**Amendments to the Drawings:**

### **REMARKS/ARGUMENTS**

The present amendment is submitted in response to the Office Action dated December 12, 2006, which set a three-month period for response, making this amendment due by March 12, 2007.

Figure 1

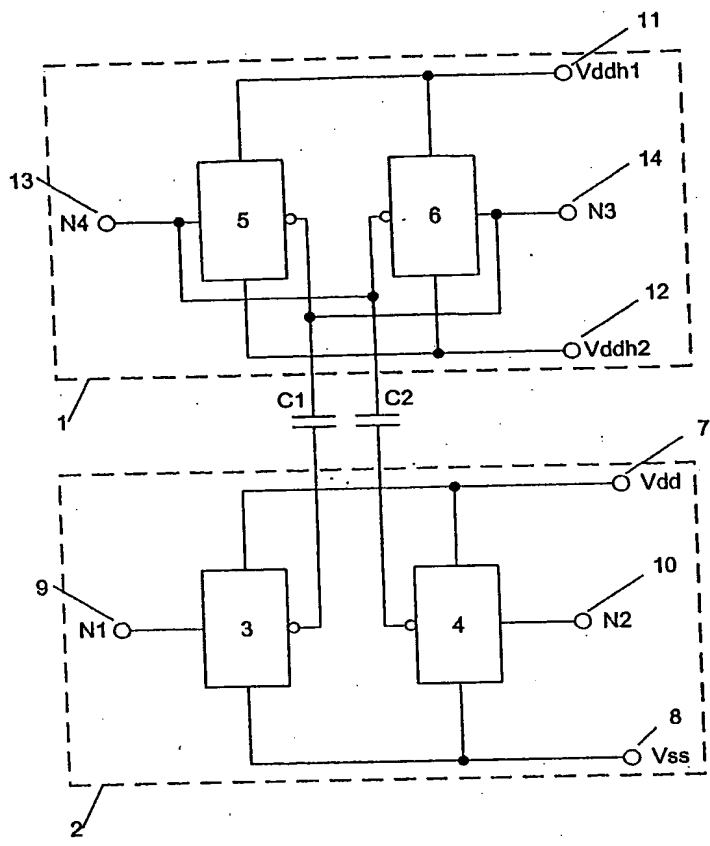
The attached sheet of drawings includes changes to Figs. 1-5. These sheets replace the original sheets including Figs. 1 – 5. In all of the figures, the term “Figur” was replaced by “Figure”. In Fig. 5, the boxes have been labeled.
